Department of Energy  
Washington, D.C. 20545

Docket No. 50-537  
HQ:S:83:171

NUCLEAR REGULATORY STAFF COMMENTS REGARDING PRELIMINARY SAFETY ANALYSIS  
REPORT (PSAR) SECTIONS 9.3 AND 9.13 FOR THE CLINCH RIVER BREEDER  
REACTOR PLANT

FIGURE 3A.9-1

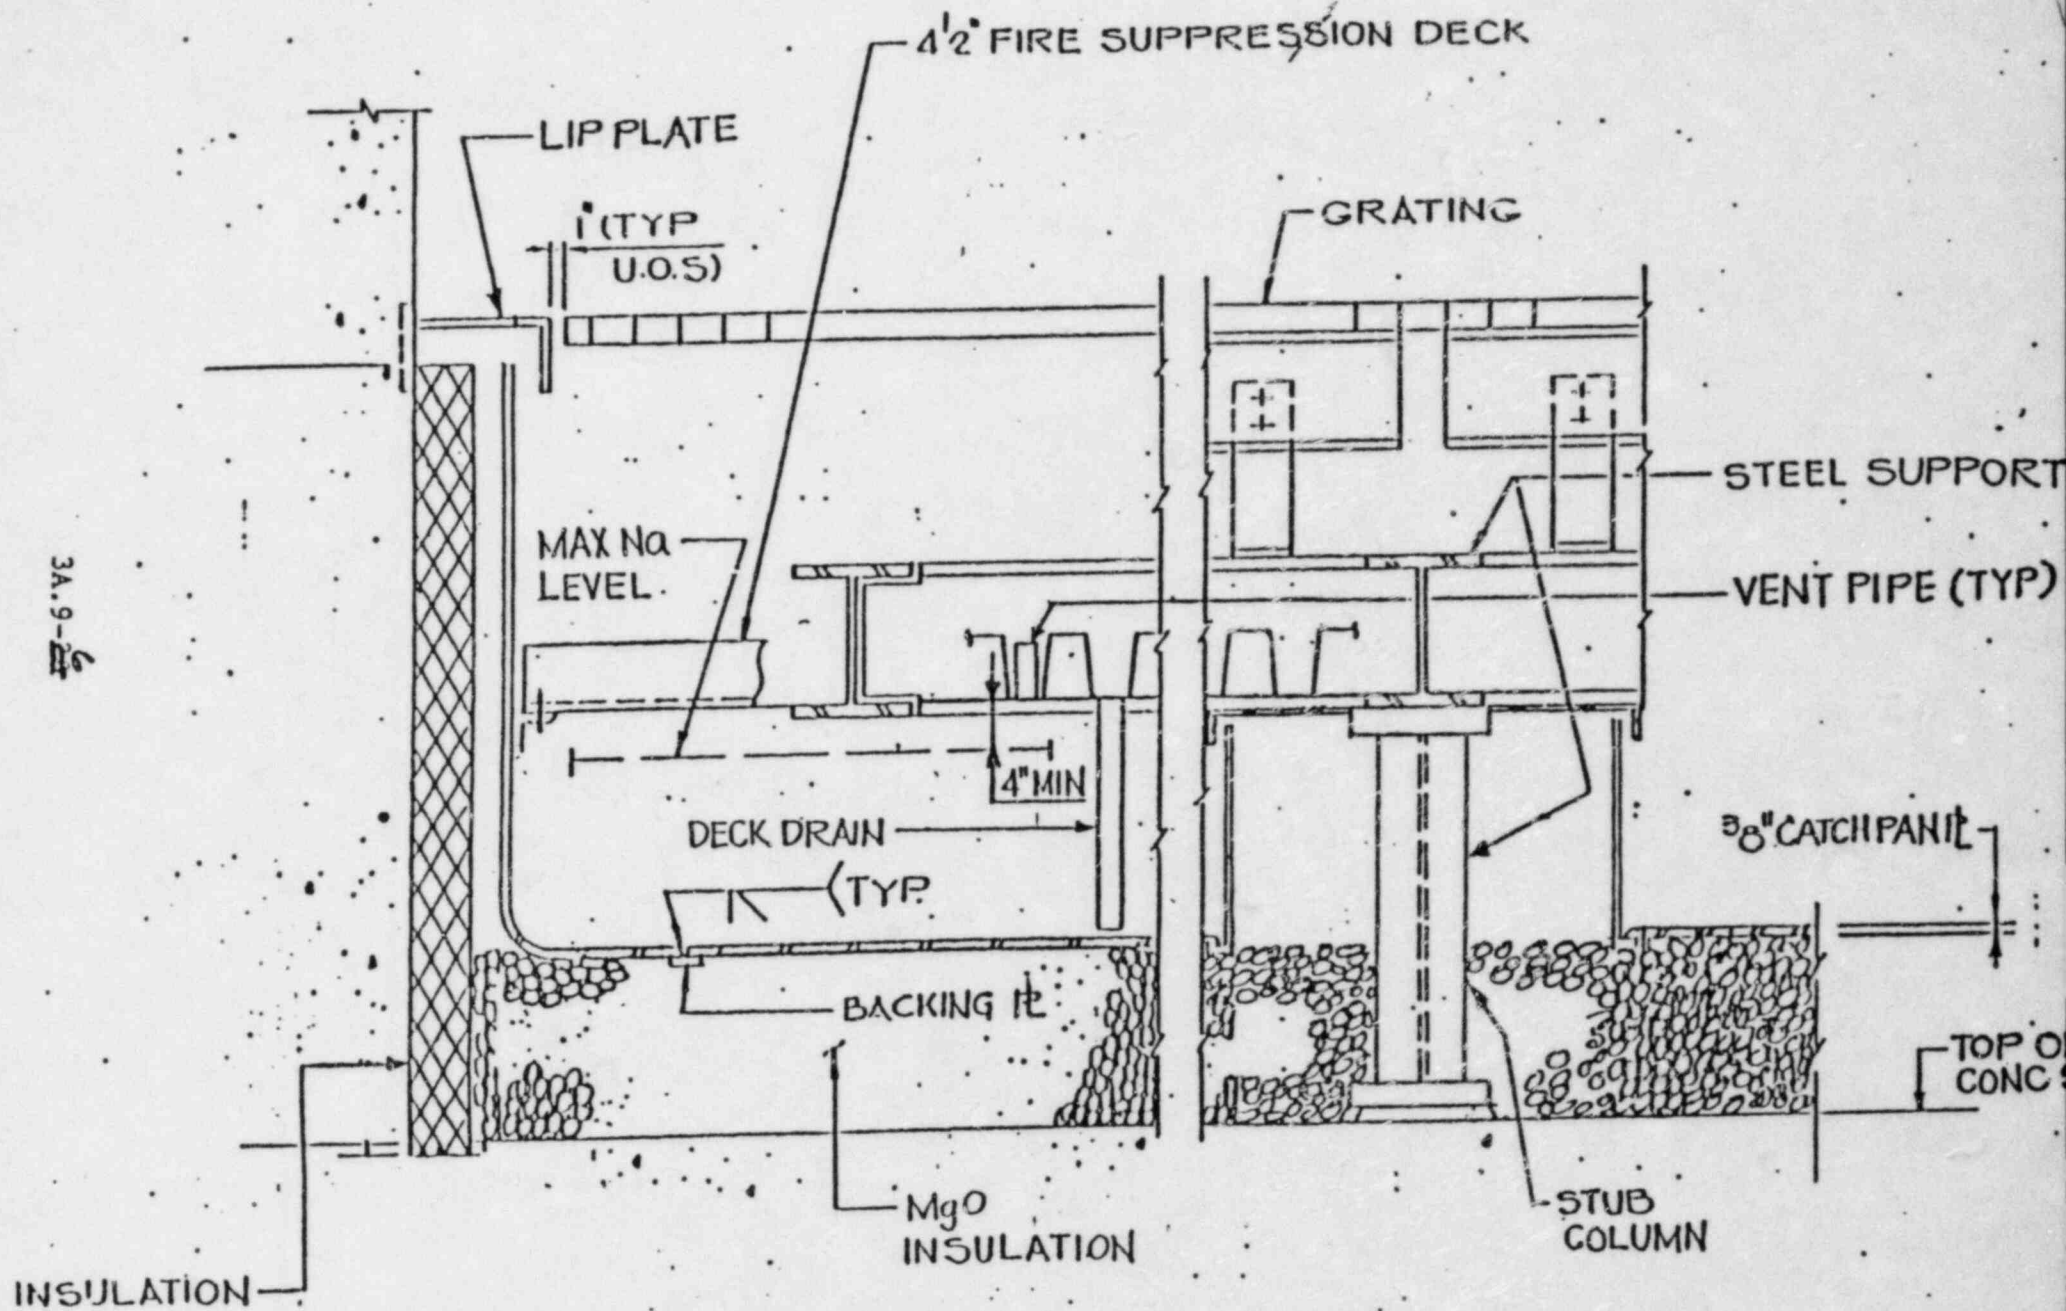
- 3) The catch pans are free floating and are supported above the concrete floor of the cells by a continuous layer of insulating material (MgO aggregate) and by steel beams. The aggregate being loose and not a solid mass would be subject to settling and have the possibility of producing bending stress in the steel catch pan if the aggregate had settled between the steel beams when a full load of sodium were to occur during an accident condition. Measures should be taken to insure that the aggregate will not settle below the level of the steel support beams or a structural analysis should indicate that the catch pan strength is adequate.

Response: The Project will specify compaction criteria for the 3/8" MgO aggregate to ensure that the height of the MgO bed is adequately maintained in conjunction with a postulated liquid metal spill event.
